06D COMPRESSORS

Section: R46

Special Note:

Read Pages 2 and 4 for variations and changes on the 06DR013, 06DR313, 06DR316 and 06DM316 compressors. Page 6 for crankcase changes.

Figure I HIGH EFFICIENCY SERVICE VALVE PLATE PACKAGE

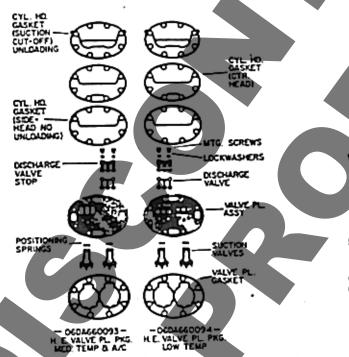
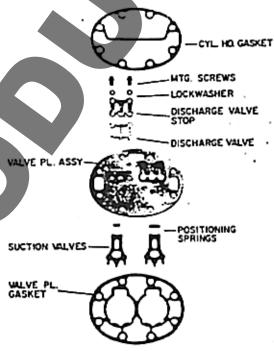
The change to new H.E. compressors involved a redesigned valve system. As a result, only 2 replacement service valve plate packages are now required for all 06DR/DM/DA H.E. compressors. Chart "F" lists the compressor model size with the applicable new H.E. service valve package along with the old standard package(s) it replaces. (See Figures I and II)

- 1. All new H.E. service valve plate packages can be used on all old standard compressors with the following exceptions:
 - a. The cylinder bore diameter on new H.E. 06DR013 and 06DM313 models has been increased (113/16" to 2" dia.). The new H.E. valve plates "can not" be used on old standard 06DR013, Ø6DM313 and 06DA313 models with the smaller (113/16" dia.) cylinder bore.

- b. The new H.E. valve plates "can not" be used as replacements on any compressor cylinder bank(s) that would continue to use the hot gas by-pass unloading. The compressor cylinder bank(s) with the old style method of unloading require the valve plate with the check valve. The H.E. valve plates do no incorporate a check valve. See also section on hot gas by-pass unloading found in this bulletin.

- c. When adding new H.E. replacement valve plates to old standard 6-cylinder compressors, it will be necessary to remove the "5th" dowel pin from the centre cylinder deck in the crankcase. The H.E. valve plates presently have provisions for only the 4-dowel pins which hold the suction reed valves. There is no mating valve plate hole for the additional 5th dowel pin and consequently, it must be removed.

- 2. All old standard service valve plate packages can still be used on old standard compressors as well as replacements on new H.E. compressors with the following exceptions:

- a. Old standard service valve plate packages designed for the 1*3/46" diameter cylinder bore "can not" be used on new 06DR013 and 06DM313 H.E. compressor models with the 2" diameter cylinder bore.

- b. Old standard service valve plate packages "can not" be used on any new H.E. "DR" compressor models because of the incompatability with the new low clearance contoured piston and mating suction reed valve. "The section clearance piston with the valve shaped cavity recessed in the head is used only on the new H.E. "Dr. ...coels . . . DM and DA new H.E. models used the conventional flat top pistons.

- c. If the valve plates must be changed on "DR" H.E. models and only standard service valve plate packages are available, the old standard service valve plate package may be used, but continue to use the existing H.E. suction reed valves. The suction valves included in the old standard service valve plate packages are not compatible with H.E. "DR" compressor models (per note 2b. above) and must not be used.

- Older "DA" 808, 313, 316 and 337 models may still exist. Valve plate requirements would be the same as comparable "DM" 808, 313, 316 and 337 models.
- 1.a. All service valve plate packages include: a valve plate assembly, (2) suction reed valves, (2) cylinder head gaskets (1 standard, 1 suction cut-off unloading), a valve plate gasket, plus (2) shut-off valve positioning springs. (See Figure I)

- b. New H.E. and old standard valve packages are interchangeable as complete assemblies only . . . as noted below. Do not intermix component parts from one type to another . . . such as suction or discharge valves, except as noted in 2.c., page 2.

Figure IV

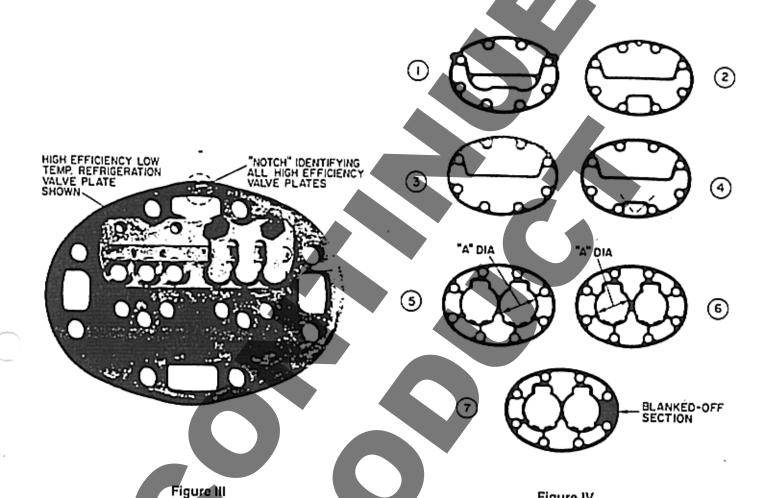
- Cylinder Head Gasket 06DA504594 Unloading Suction Cut-Off
- 2. Cylinder Head Gasket 6D75-2672 Unloading Hot Gas Bypass
- 3. Cylinder Head Gasket 6D40-1053 No Unloading Side-Bank Cylinder Head Gasket 6D40-1053 can be made from Gasket #4 (6D68-1053) by removing web as shown by cut lines.
- Cylinder Head Gasket 6D68-1053 No Unloading Centre Deck
- Valve Plate Gasket 6D43-1043 Ref. "A" dia. = 2" dia.

- Valve Plate Gasket 6D40-1043 Ref. "A" dia. = 113/16" dia.
- Valve Plate Gasket 06DA502923 Blanked-Off Section For 16-CFM Models with S.V. located at P.E. of compressor and using H.E. Valve Plates . . . See note 3d, page 4.

- d. When using the new H.E. service valve plate packages on old standard DR316 and DM316 models with the suction service valve located at the compressor pump end, a special valve plate gasket must be used. This special gasket, part number 06DA502923, will be included in the 06DA660093 and 094 package and is required only for the old standard 16 CFM models. (See Figure IV, Gasket #7, Page 5) The gasket is to be placed on each of the two cylinder decks with the "blanked-off" section always toward the oil pump end of the compressor. In this position, the gasket allows the suction gas to pass over and cool the motor first before being drawn into the cylinders.

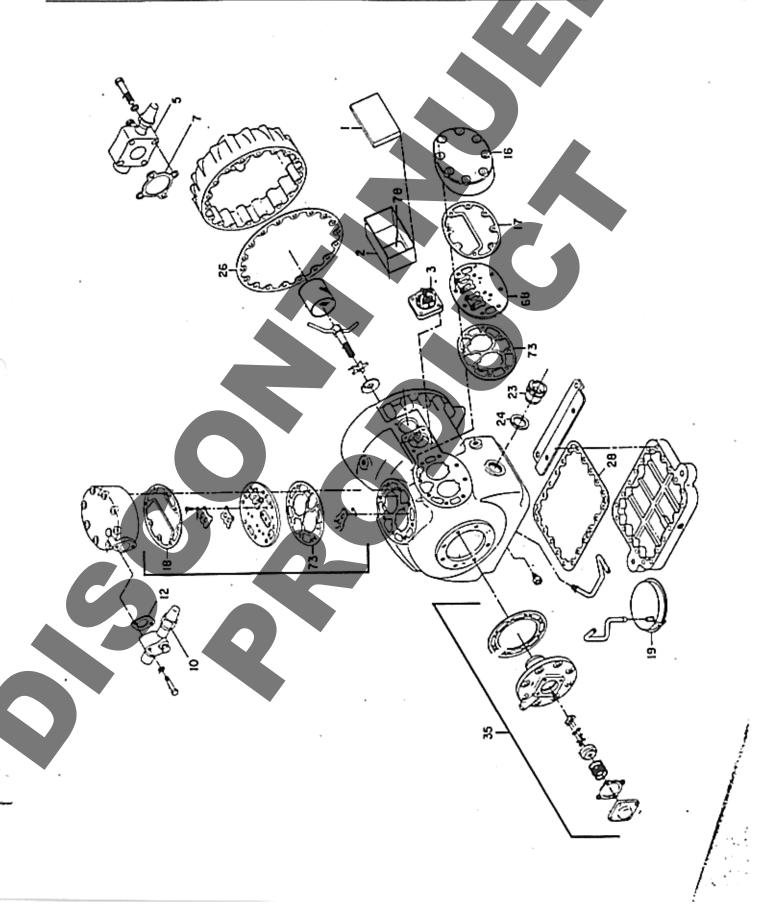
The suction cut-off method of capacity control has replaced the old hot gas by-pass unloading design. However, many 06D 6-cylinder compressors now in operation use this old hot gas by-pass means of unloading. The hot gas by-pass capacity control design has a unique valve plate with a built-in check valve. If it becomes desirable to change the unloader cylinder head assembly or the valve plate, note the following recommendations:

- 1. The hot gas by-pass unloader head can be replaced with the new suction cut-off capacity control design. Use capacity control package 06DA660089 (elec.) or 06DA660090 (press.). Existing solenoid coils will not fit the new suction cut-off unloader valve stem. It is not necessary to change the valve plate when converting to the new suction cut-off unloading design. However, it is recommended to remove the check valve from the existing valve plate before adding the new suction cut-off cylinder head. This can be accomplished by taking the valve plate off the compressor. Then remove the screws holding the check valve body. Discard this body and the piston and spring which it houses. Reassemble the old valve plate using a new valve plate gasket included in the new suction cut-off unloader package.

- If it is desirable to change the valve plates and maintain the old style hot gas by-pass method of unloading, the valve plate with the check valve (P/N 06DA401843) must be used with the old style unloader cylinder head. The new H.E. valve plate packages (06DA660093 or 094) can not be used with the old style hot gas by-pass cylinder head unloader.

- 3. If the replacement valve plate assembly with the check valve (06DA401843) is unavailable for use with the old style hot gas by-pass method of unloading, the following option exists: Change the unloader cylinder head assembly from the old hot gas by-pass to the new suction cut-off head as per note #1 above. With the new suction cut-off unloader head, H.E. valve plate packages (06DA660093 or 094) can now be used.

06EA401303 - 208V Coil - Hot Gas By-Pass - Fastened with nut on threaded valve shaft

504696 (06DA401794) - 208V Coil - Suction Cut-Off - Fastened with spring clip on valve

Valve not available for 06EA401303 coil; use 504696 (06DA401794) and 06EA660135.

Figure 2 - 06EX CYLINDER HEAD SENSOR AND OVERCURRENT PROTECTED COMPRESSORS

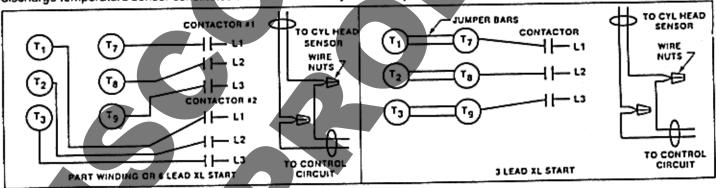
All 06EX service compressor models are supplied with cylinder head sensor installed to provide improved motor protection; 06EX models are a direct replacement for original compressors using calibrated overcurrent protection devices and cylinder head sensor protection. Wire per Figure 2.

When replacing original compressors which used the Robertshaw protection system, rewire per Figure 2, using conduit package P/N 06EA601052 (should be ordered along with the service compressor). Wire the cylinder head sensor leads through the compressor terminal box using the black wire and one of the three orange wires that were previously connected to the Robertshaw sensor terminals. Connect orange and black leads to the original control circuit wires removed from the M1 and M2 terminals on the module. Remove and discard the old Robertshaw module and the (2) extra orange sensor leads. Disconnect the module power leads T1 and T2 and insulate or tape off. Complete the terminal box connections per Figure 2.

Original compressors using obsolete thermotector protection must be converted by addition of P/N 06EA601052 conduit kit. Connect the cylinder head sensor leads to original thermotector leads and wire per Figure 2.

Figure 3 - 06EY-EZ ROBERTSHAW PROTECTED COMPRESSORS

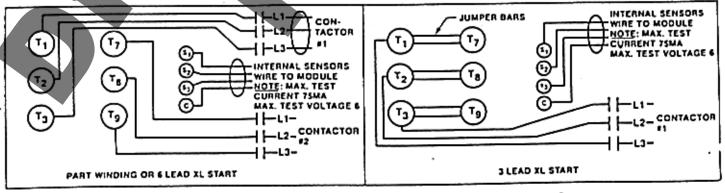
All 06EY and 06EZ refrigeration duty service models are supplied with Robertshaw sensors embedded in the motor windings and either the centre head on six cylinder or side head on four cylinder models are tapped and plugged to accept a ½ MPT discharge temperature sensor. If original compressor has the sensor, transfer it to service compressor and install the plug in the return compressor. Use a good grade of pipe thread sealant such as John Grane plastic lead seal, insoluble #2 (Grane Packing Company) or equal. Wire the head sensor leads into the control circuit and complete the terminal box connections per Figure 3.

WARNING: Application to sensor terminals of any voltage or current in excess of those specified in Figure 3 results in immediate damage to sensors. Failure to use approved over current protection in conjunction with either the Robertshaw protection or the discharge temperature sensor constitutes abuse and warranty-credit may be denied.
